Hydraulic Review Technical Memorandum

San Francisquito Creek Flood Protection Capital Project

**Floodwater Conveyance Improvements from
East Bayshore Road to San Francisco Bay**

SAN FRANCISQUITO CREEK
JOINT POWERS AUTHORITY

Manning's n-Values – Typical Section with Floodwalls

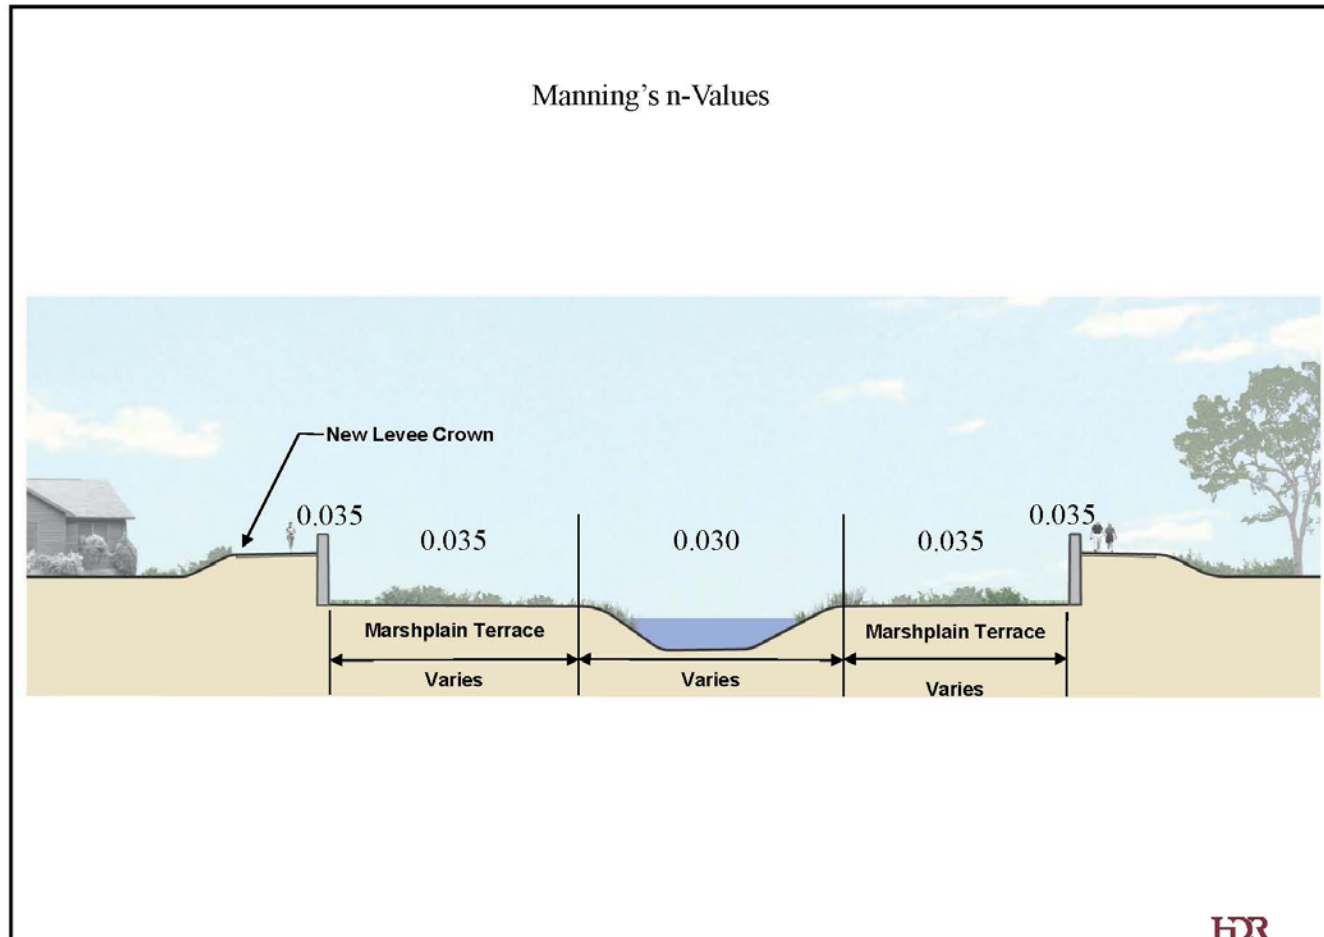
Manning's "n" values, or roughness coefficients, selected by PWA were reviewed and deemed appropriate for the proposed design conditions. The proposed channel configuration is fairly uniform throughout the entire project limits; therefore, it was anticipated to see fairly consistent roughness coefficients throughout the creek. Cross-section 2+00 was revised to reflect a lower channel roughness coefficient of 0.030 instead of 0.050 which was contained in the PWA model. The coefficient was revised to better match channel roughness coefficients for the rest of the downstream portion. See Figures 1 and 2 for typical Manning's "n" value distribution through cross-sections for both levee and floodwall sections.
